# Wollongong Local Planning Panel Assessment Report | 7 June 2022

<b>WPP No.</b>	Item No. 4
<b>DA No.</b>	DA-2021/1117
<b>Proposal</b>	Residential - demolition of existing structures and construction of a residential flat building
<b>Property</b>	1-3 Church Street, WOLLONGONG
<b>Applicant</b>	PRD Architects
<b>Responsible Team</b>	Development Assessment and Certification – City Centre Planning Team (NL)
<b>Prior WLPP meeting</b>	NA

## ASSESSMENT REPORT AND RECOMMENDATION

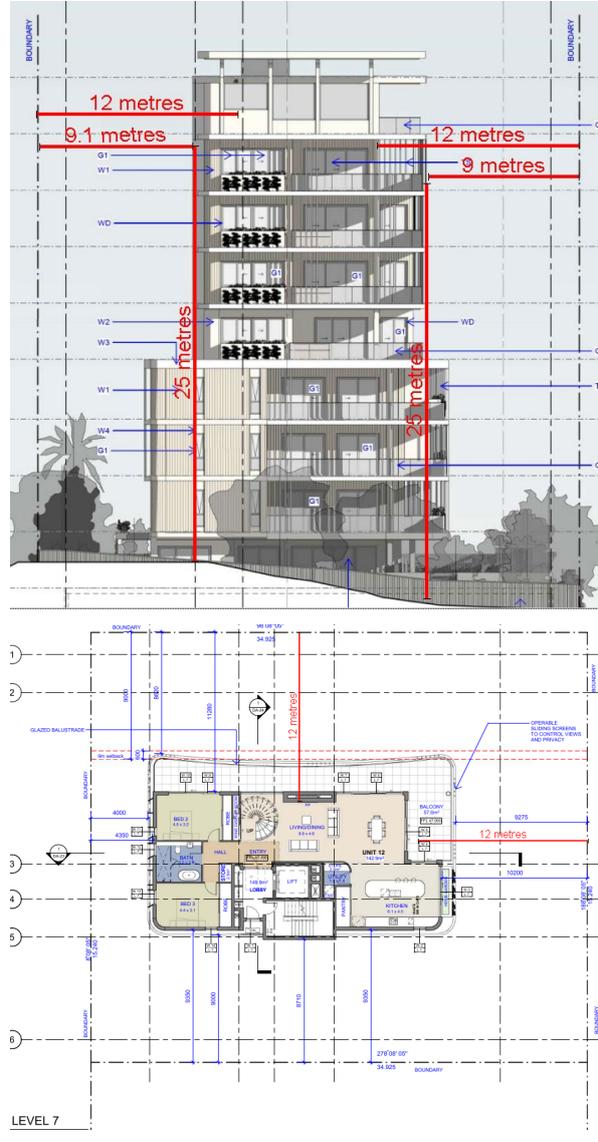
Overshadowing impacts to adjoining residences

A non-compliant setback occurs at level 7 and 8, being 9m where 12m is recommended as illustrated below.

Whilst there is overshadowing from the proposal, it is not unreasonable with regard to the height and density envisaged by the planning controls.

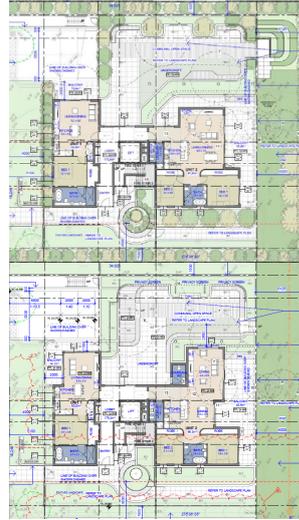
The deletion of the sub-station is noted; confirmation from the relevant authority that it is no longer a requirement should be provided with the DA.

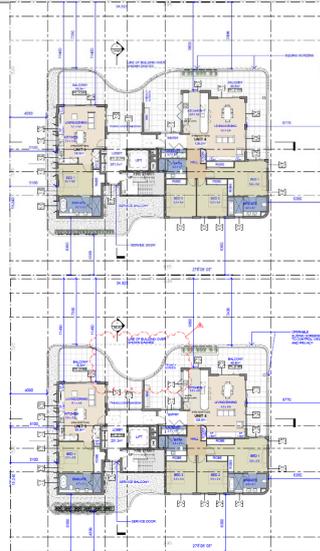
The northern edge of the ground floor communal open space is elevated approximately 2m above natural ground level, creating potential privacy issues with the adjoining neighbour and a deep narrow setback between the boundary fence and the building base. Detail resolution should seek to minimise potential privacy issues and ensure a serviceable landscaped interface is provided adjacent to the northern boundary.

The edge to the COS area is provided with a setback landscape bed and privacy screen as illustrated below.

The podium is set back 1.5m from the boundary and is readily accessible.

The setback will be planted with a hedge (suggested species are *Acmena smithii* & *Camellia japonica*)

**Figure 3: Level 7 non-compliant setbacks**

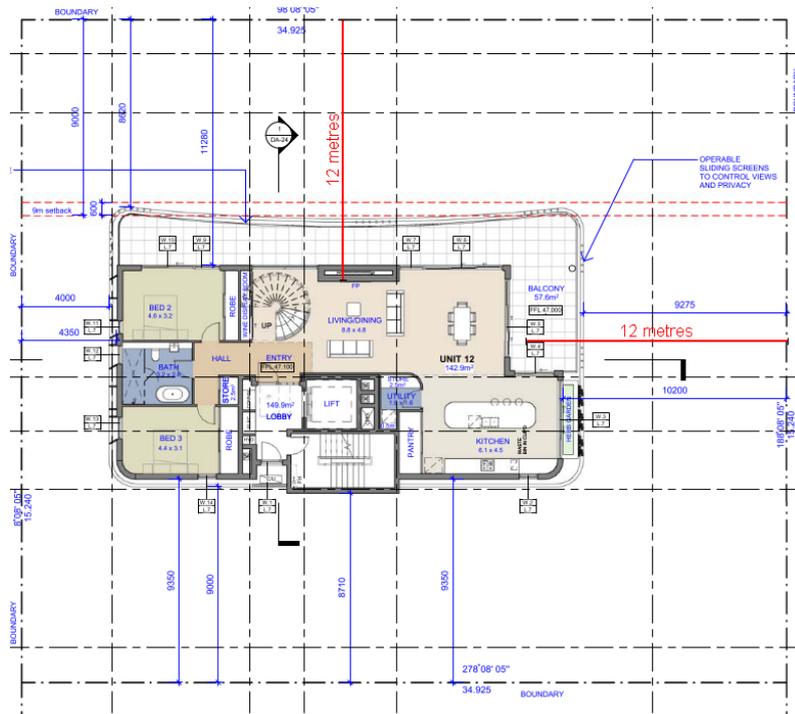
between 12m & 24m (levels 3-6)	Required	
- side and rear setback to habitable rooms with openings and balconies	9m	7.35m (side) 6.35m (rear)
- side and rear setbacks to non-habitable rooms and habitable rooms without openings	4.5m	
above 24m (levels 7-8)		
habitable rooms with openings and balconies	12m	9m

Impacts are discussed above. In addition, on the floors at which the side setbacks do not comply, there are no corresponding buildings in the same height plane, being existing, lower residential flat buildings to the north and east. To site to the south contains a single dwelling house and is not of a sufficient size to accommodate a building of the same height as the proposal. In this regard, impacts on visual privacy in the areas of non-compliance is minimal.

**3 SECTION B-B - PLANTER DETAIL**  
 1 : 10

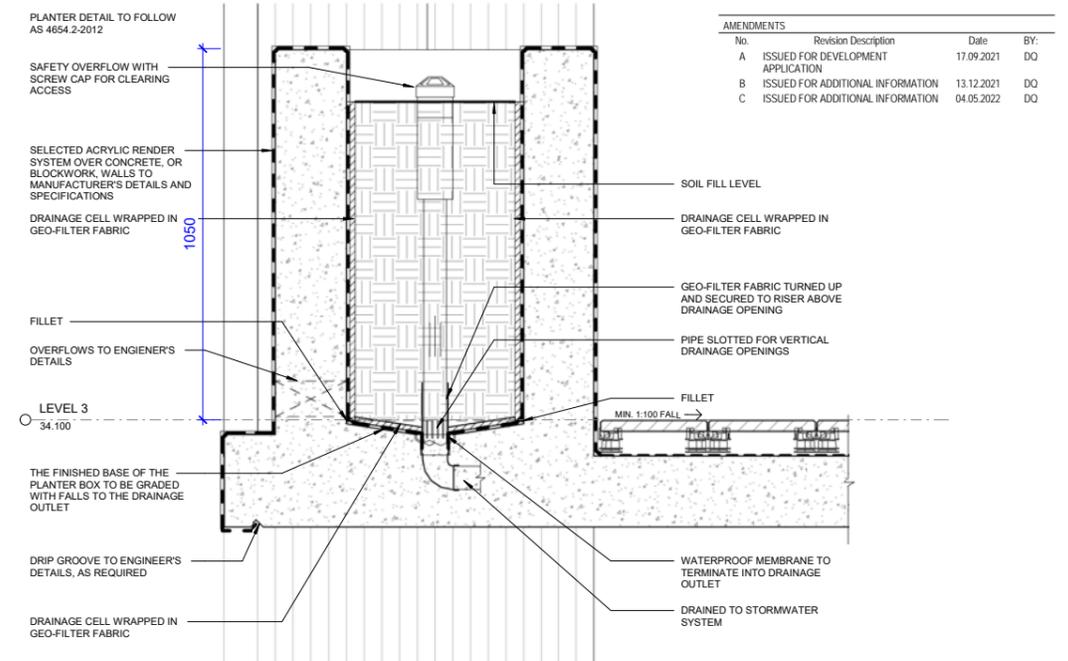
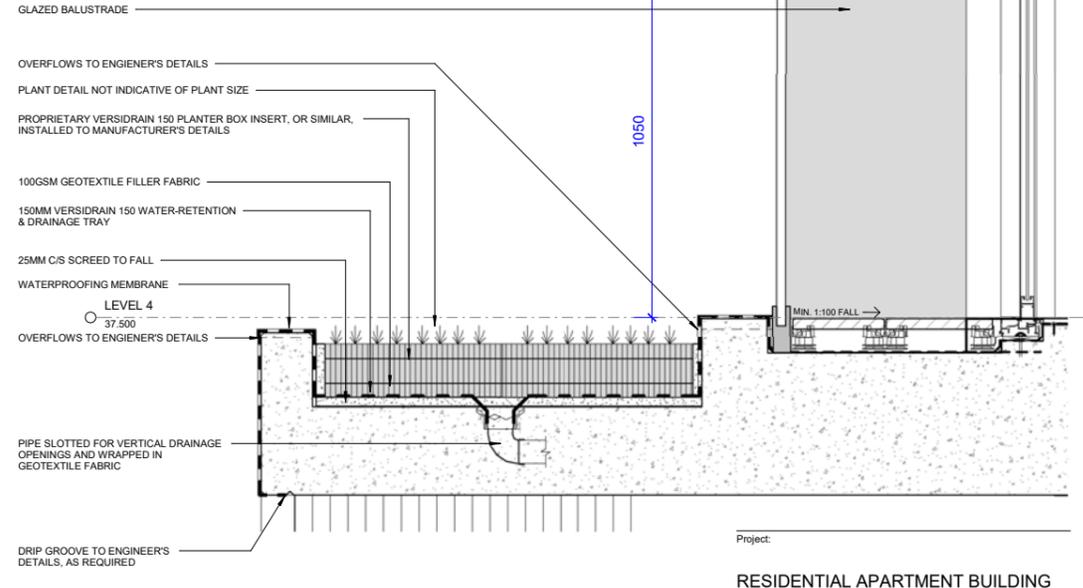
Planters are shown in numerous locations on the façade. They will potentially provide a positive contribution to the building aesthetic. However, further detail development is required to integrate the planters into the building form. In particular, it should be clarified how the planters

<p>Further detail information is required to ensure that the design intent is realized. A larger scale detail section would assist in providing a better understanding of the quality of finish being proposed and also help to ensure that the architect's design intent is realised.</p>	<p>The elevations include a finishes schedule and there is considered to be sufficient detail to be confident the presentation of the scheme in the DA documents can be realised in the constructed product.</p>

The planter systems have been detailed in the documentation for the applications on various levels. The depth of slab profiling to accommodate this is also shown on the documents which have been submitted to council.

The information for planters have been provided on the documents and are in harmony with the requirements of the Landscape Architect.
